**CONTRACT ADDENDUM #**

**date:** 5.10.24  
**project:** Nibley Middle School  
**by:** Michael Rigby  
**subject:** Addendum 02

Clarification and changes from Bid Package 1 to Bid Package 2. Includes update to the concrete openings, structural items – see structural narrative, and civil items – see civil narrative.

**SUBJECT:** Addendum #2 – Changes to Bid Package #1

PLAN - LEVEL 01 - AREA A - SLAB & FOUNDATION

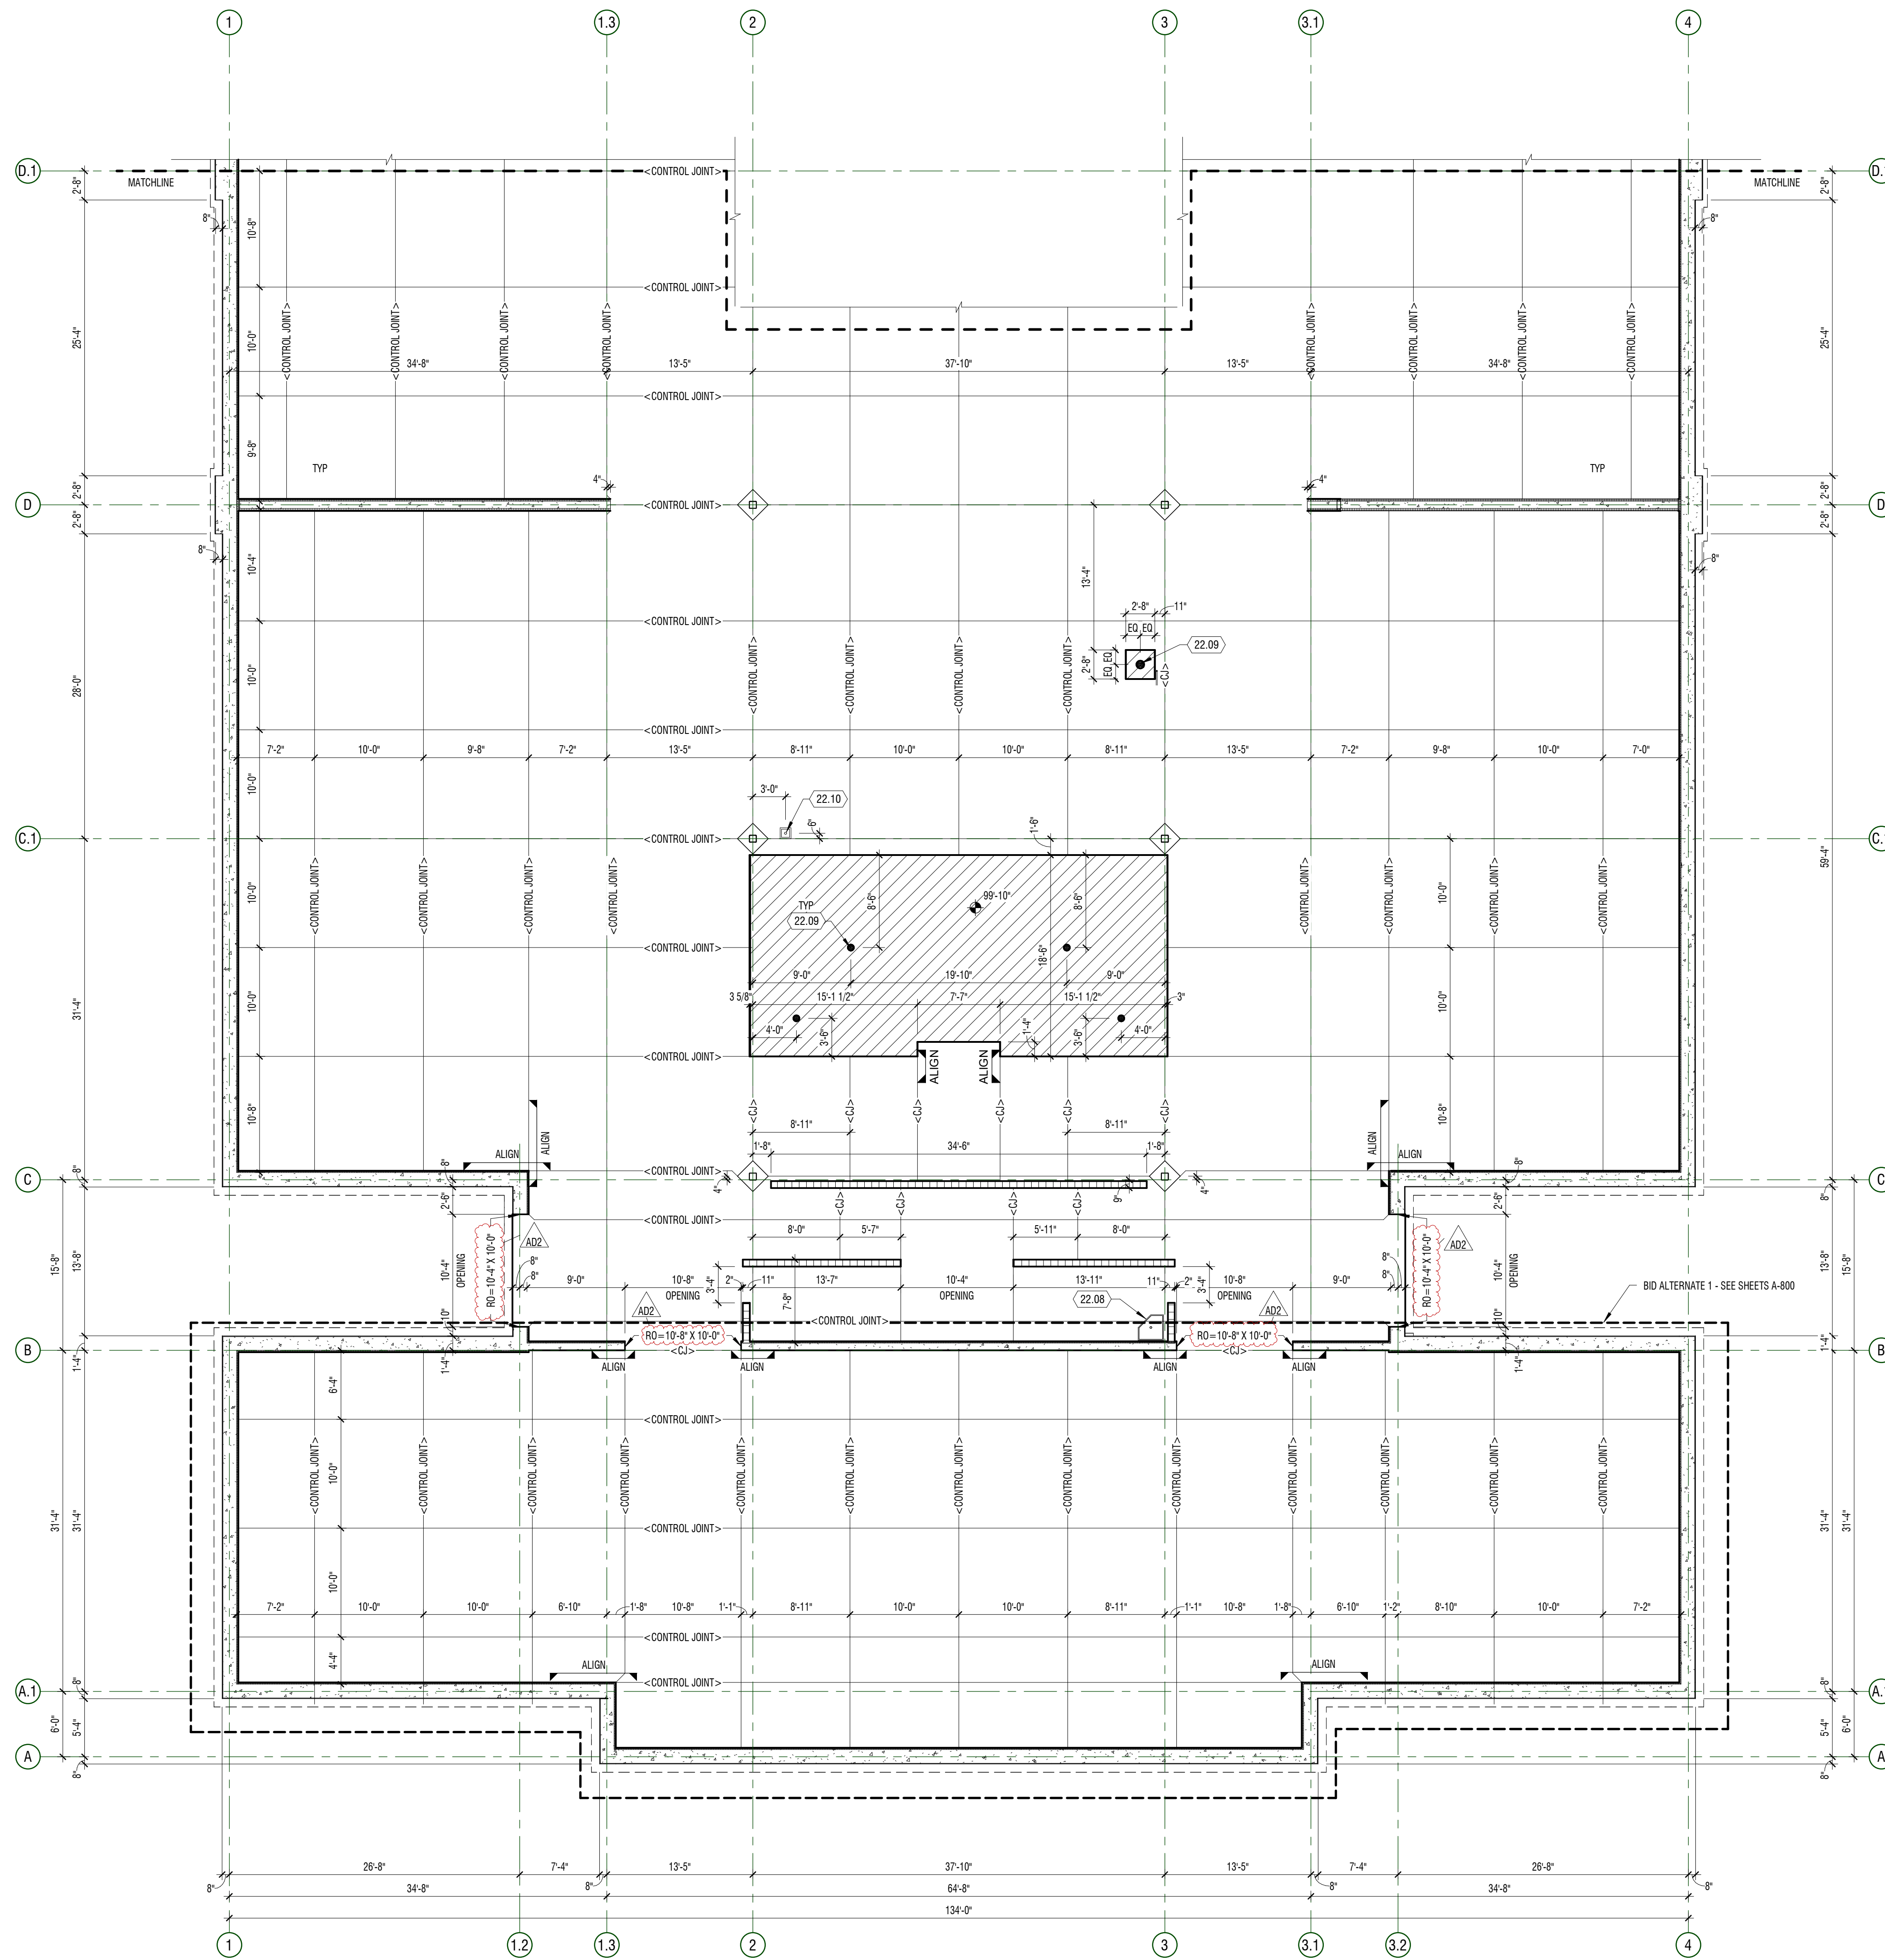
- 02.01      A-111.0 – PLAN – LEVEL 01 – AREA A – SLAB & FOUNDATION
  - ROUGH OPENING (RO) OF CONCRETE/ICF OPENING.
- 02.02      A-112.0 – PLAN – LEVEL 01 – AREA B – SLAB & FOUNDATION
  - ROUGH OPENING (RO) OF CONCRETE/ICF OPENING.
- 02.03      A-113.0 – PLAN – LEVEL 01 – AREA C – SLAB & FOUNDATION
  - ROUGH OPENING (RO) OF CONCRETE/ICF OPENING.
- 02.04      A-114.0 – PLAN – LEVEL 01 – AREA D – SLAB & FOUNDATION
  - ROUGH OPENING (RO) OF CONCRETE/ICF OPENING.
- 02.05      A-115.0 – PLAN – LEVEL 01 – AREA E – SLAB & FOUNDATION
  - ROUGH OPENING (RO) OF CONCRETE/ICF OPENING.
- 02.06      A-115.0 – PLAN – LEVEL 01 – AREA F – SLAB & FOUNDATION
  - ROUGH OPENING (RO) OF CONCRETE/ICF OPENING.
- 02.07      See attached Civil Items
- 02.08      See attached Structural Items

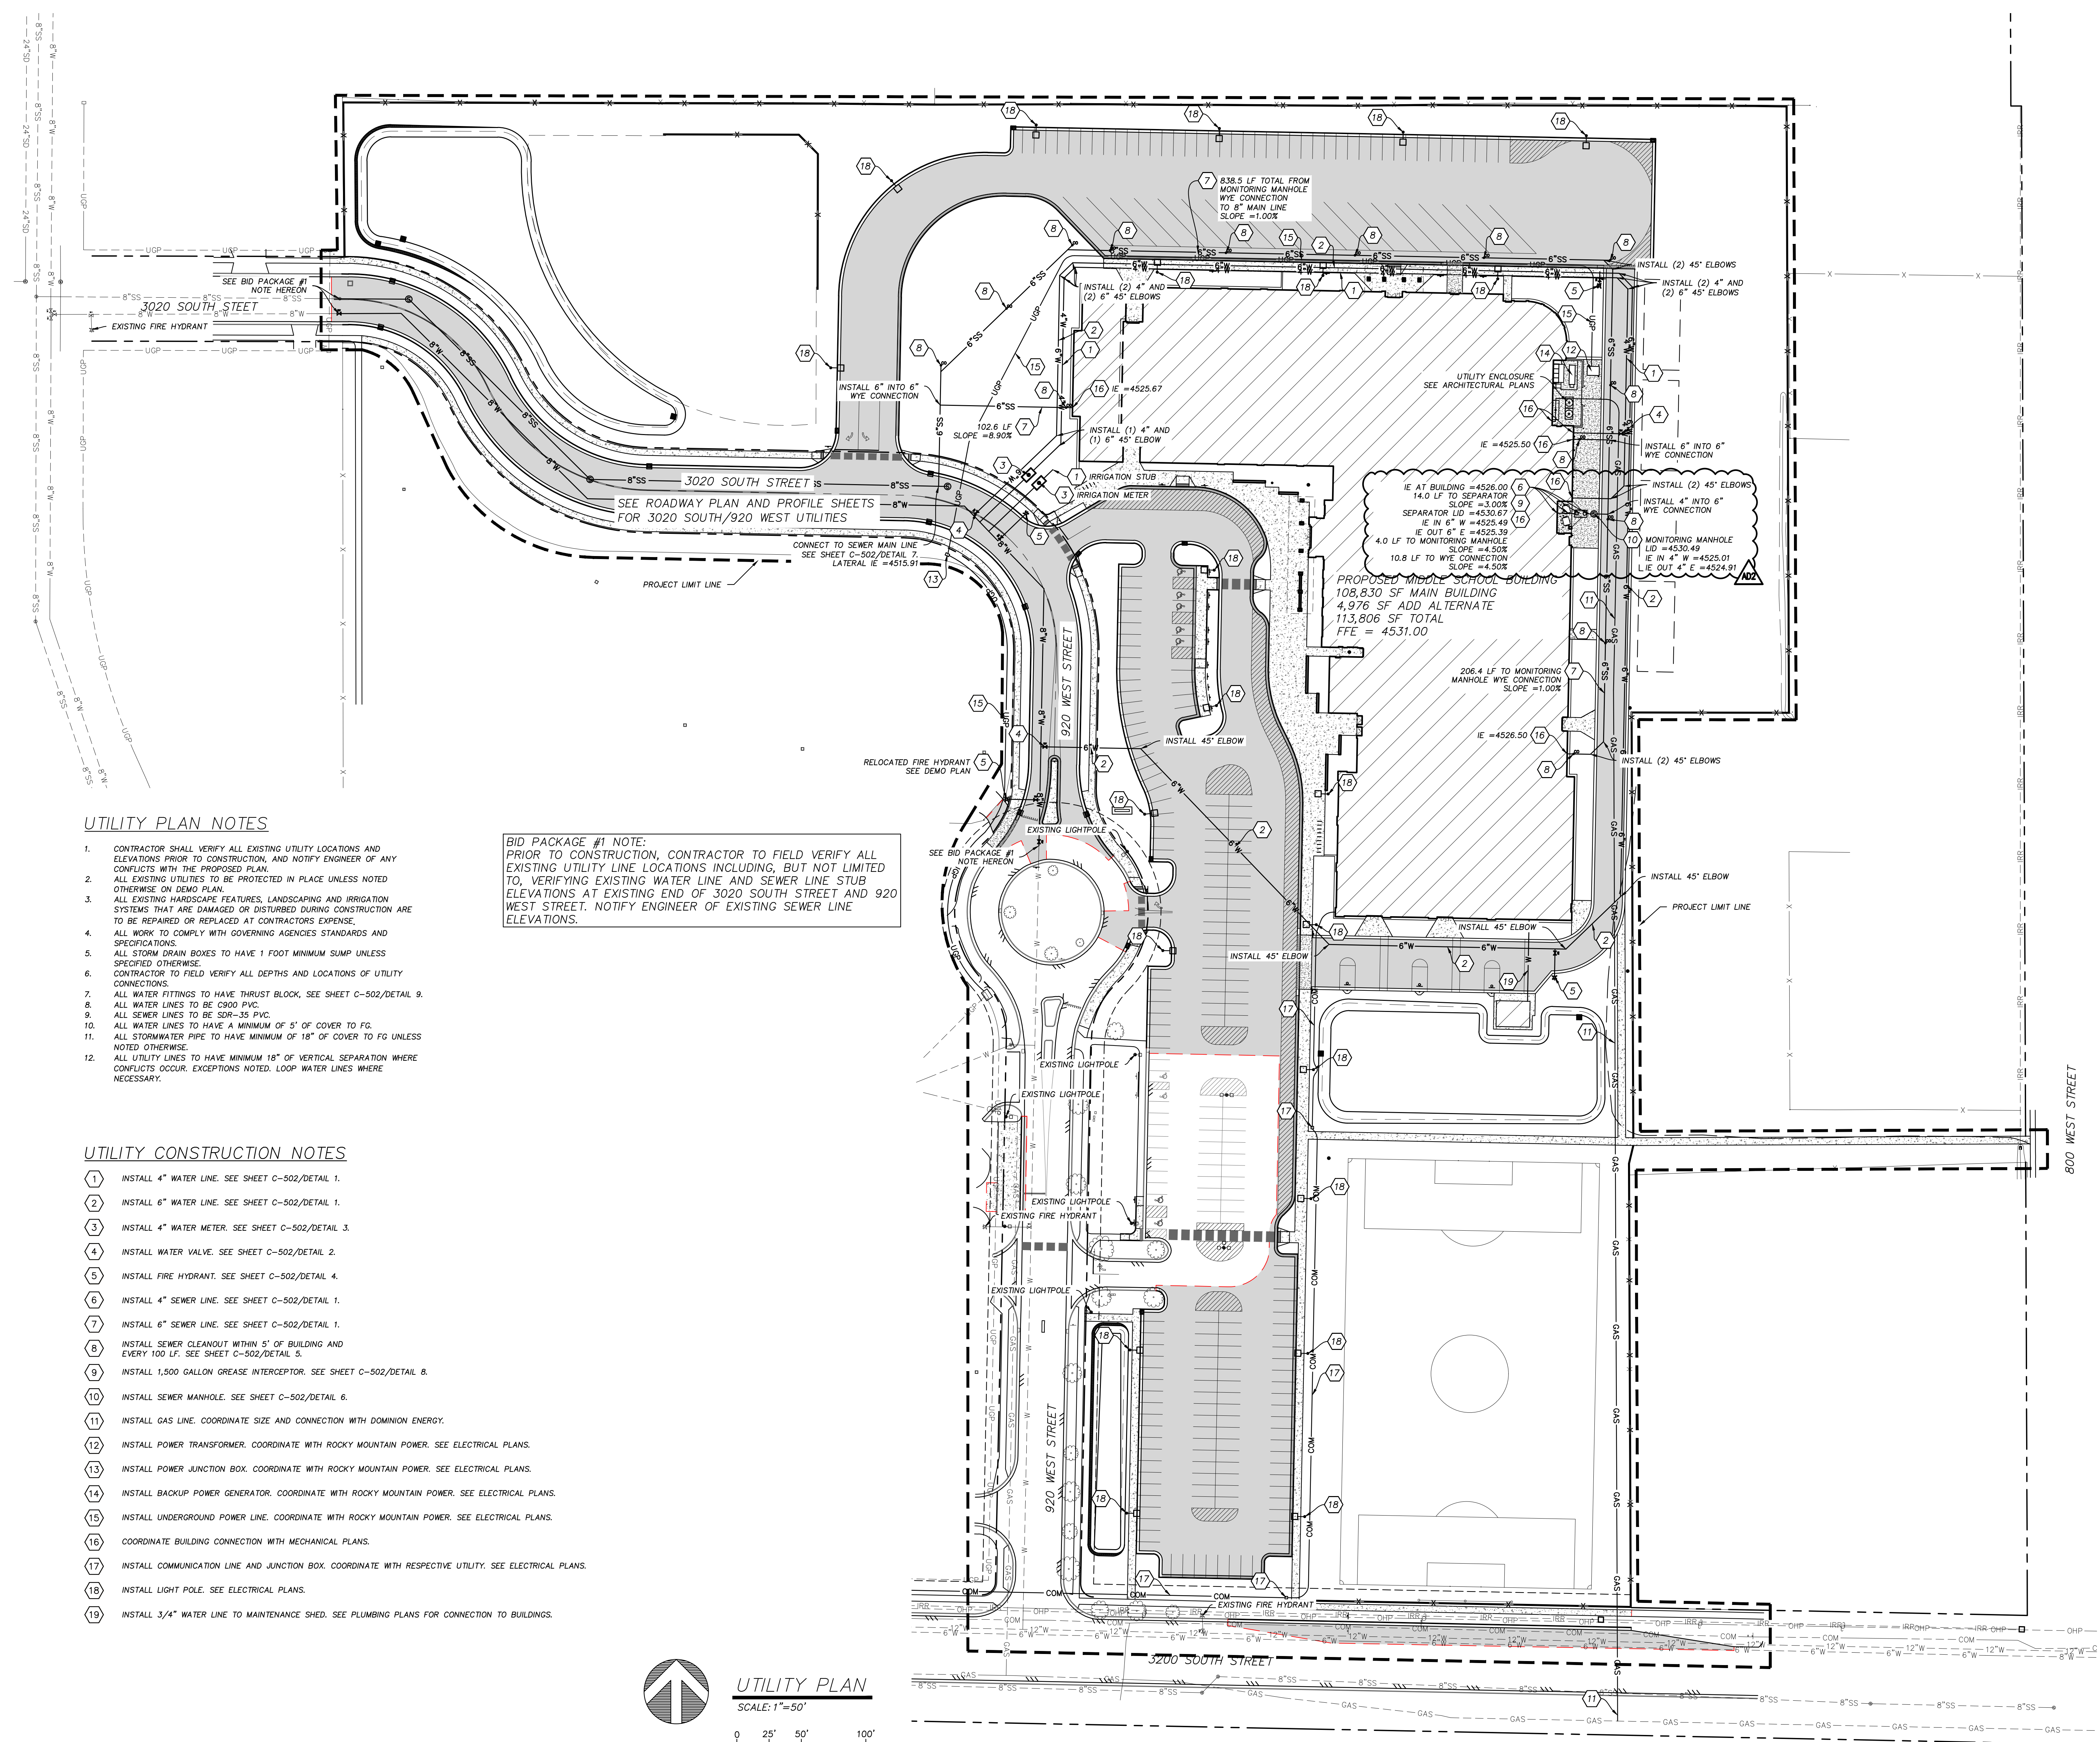
2. **Civil – Utility Plan, Sheet C-301.**
  - a. **CHANGED** – Location of monitoring manhole adjusted to prevent contamination from 6” sewer line (human waste).
  - b. **CHANGED** – Elevations of grate and pipes for monitoring manhole.
  - c. **CHANGED** – Location of grease interceptor adjusted to accommodate change to monitoring manhole.
  - d. **ADDED** – 4” into 6” WYE connection at previous monitoring manhole location.
  - e. **ADDED** – Sewer line cleanout upstream of WYE connection.
